O2 DARM Loop Design Comparisons and Critiques

E. Goetz, J. Kissel, for the Calibration Team

Actuator Comparison (Hierarchy Filters)

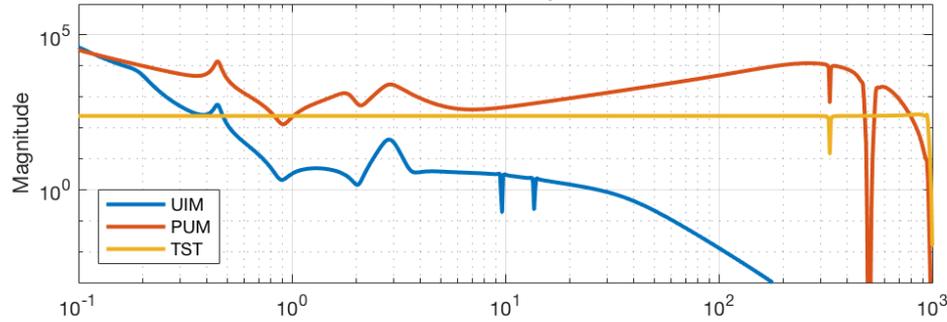
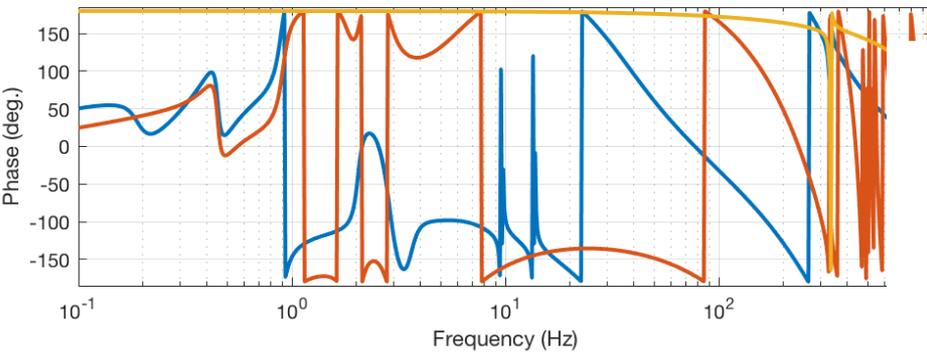
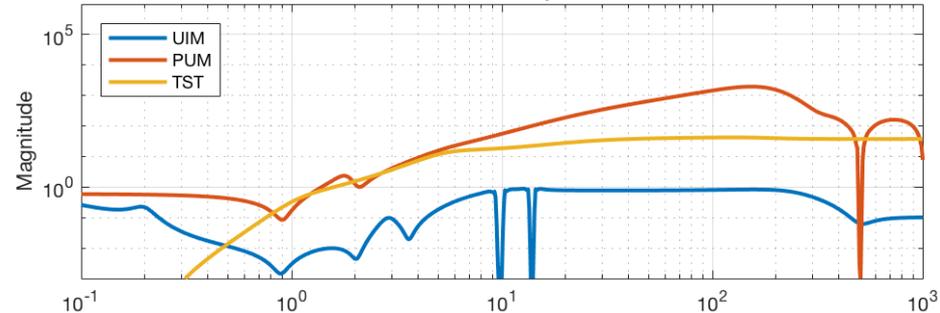
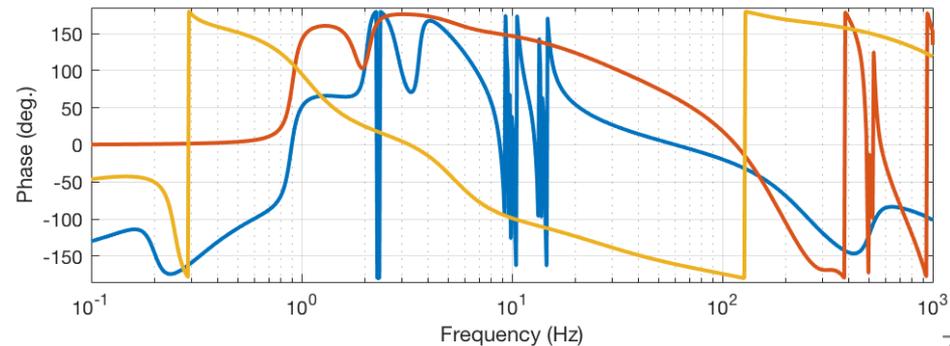
Both sites have a mish-mash of “offloaded” vs. “distributed” hierarchy filters due to staggered design

L1 does more loop shaping in the DARM bank (because of all the notching done at H1)

Note the difference in HF cut-off filter for all stages...

The DARM Filter and Sensing Function

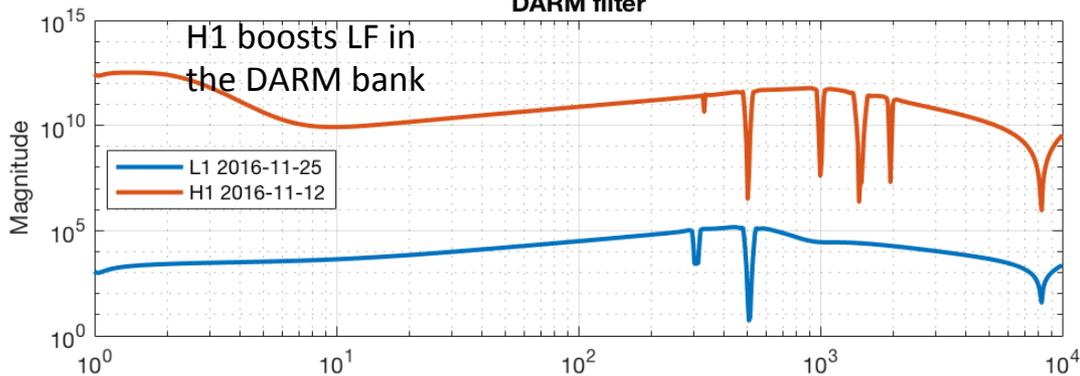
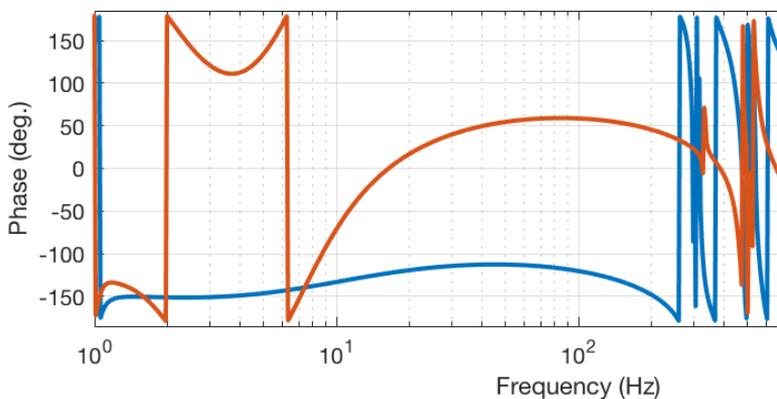
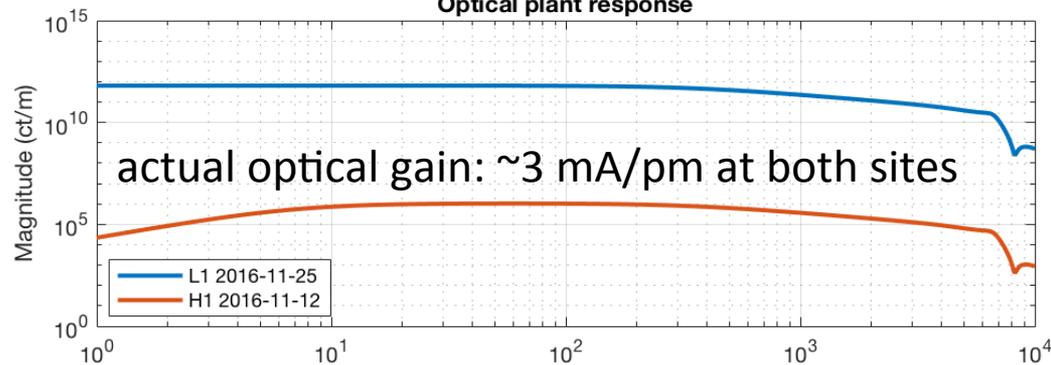
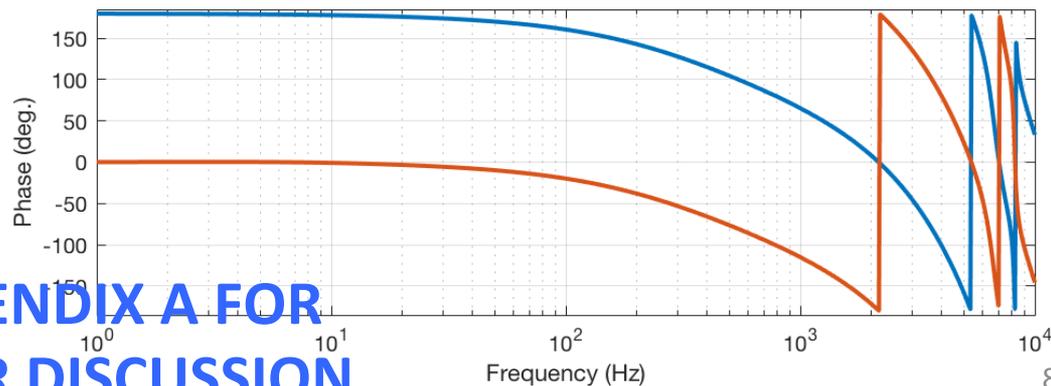
Digital gains (and a sign) are distributed differently on the sensing side, so DARM filter gain and sign compensate, otherwise pretty similar...

But because of the **different design choices**, with frequency response and gains all over the place, **tough to get a feel for the loop shaping from just one filter or plot**

H1DARM_IN1 / OMC_DCPD_SUM Digital TF
Data From Mar 21 2017 22:19:25 UTC

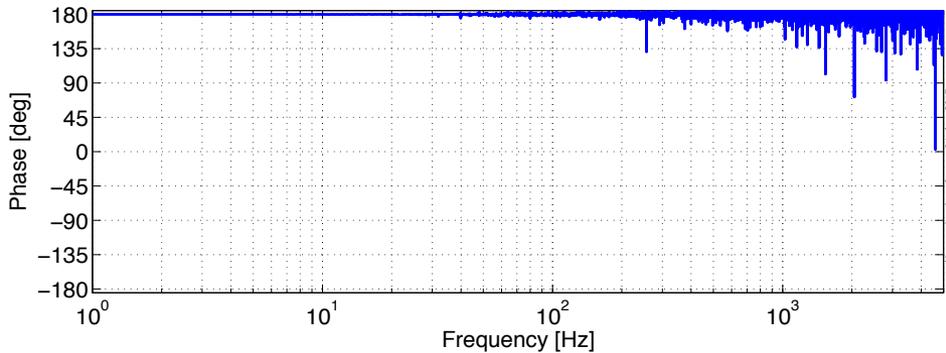
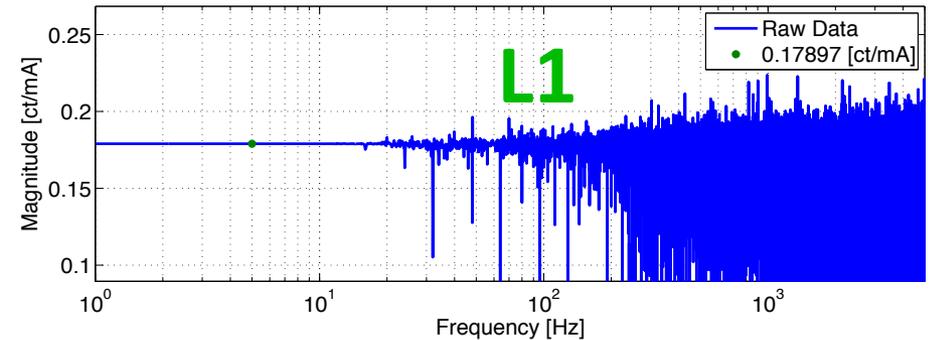
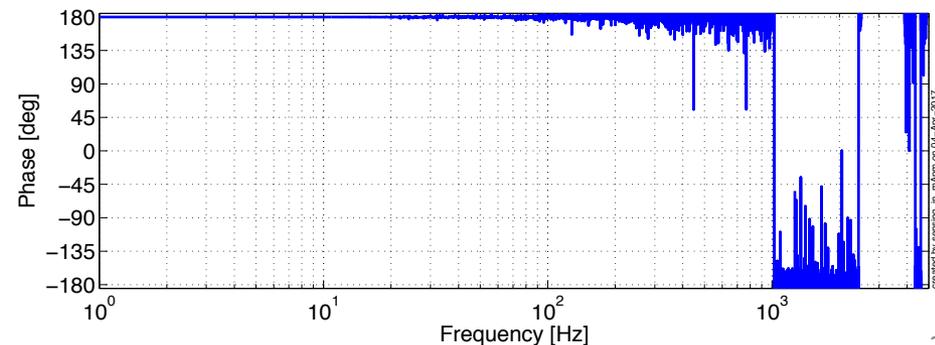
This explains the difference between the site's transfer function between the OMC DCPD SUMM (in [mA]) and DARM_IN1 (i.e DARM_ERR in [ct])

So, if we use this entirely digital transfer function to “correct” (namely, undo) the sensing function from DARM_ERR counts to mA on the DCPDs, we get....

2017-01-03 H1 Sensing Function Model

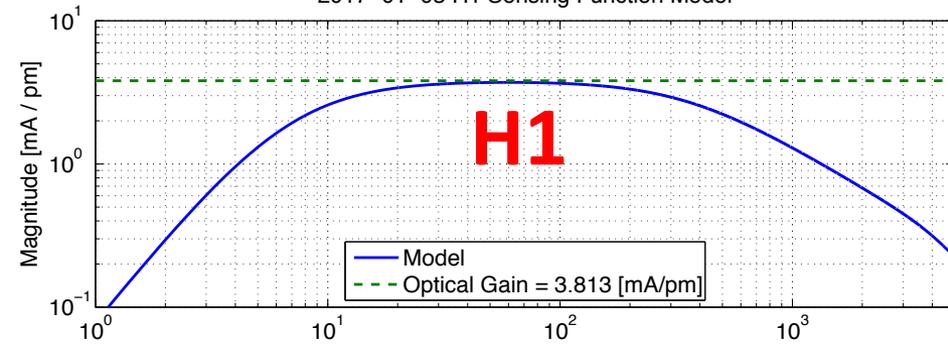
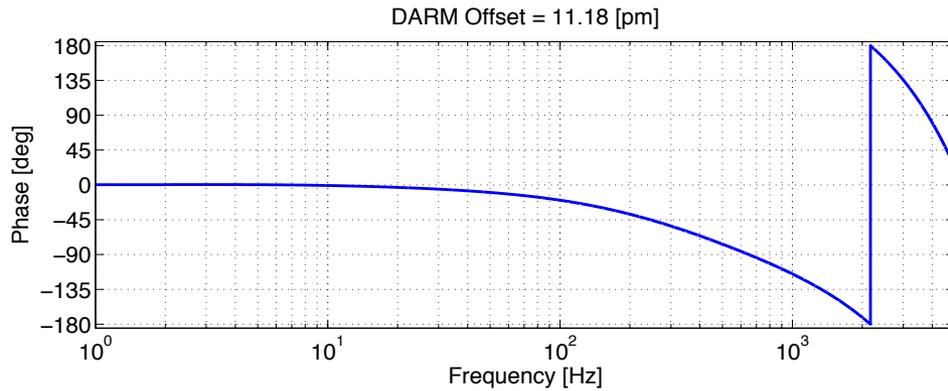
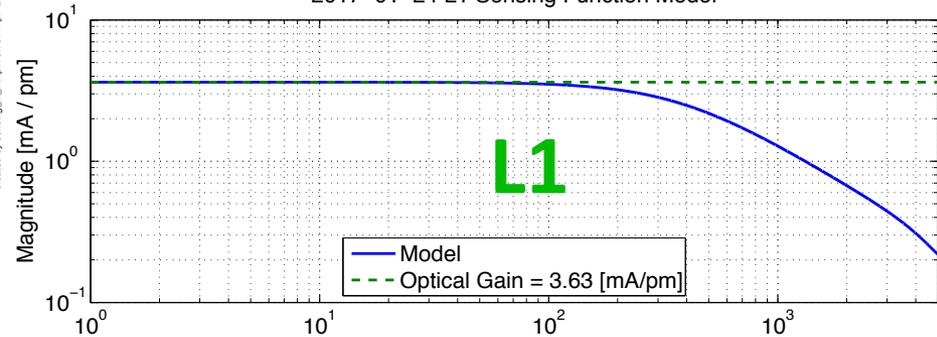
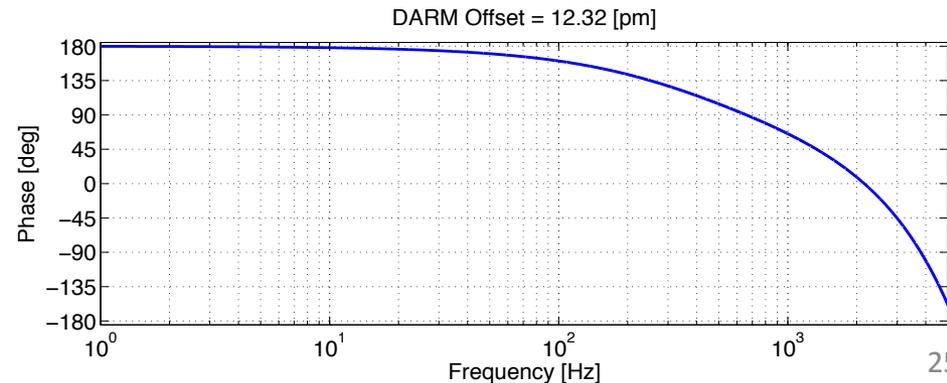
The modeled optical gain is about ~ 3.7 [mA / pm] for both observatories (and remember, measurement matches our model very well).

BUT, that “mA” is an function of how well commissioners filled out the DCPD banks – namely the “V2A” and “HiZ” filter modules in the OMC DCPD Banks

- the sites also chose different sides the the quadratic for the DARM offset, so the phase is 180 different at low frequency.
- Remember L1 doesn't include any SRC detuning, because they hadn't been able to measure it before O2 (now they have, see LLO aLOG 32495)
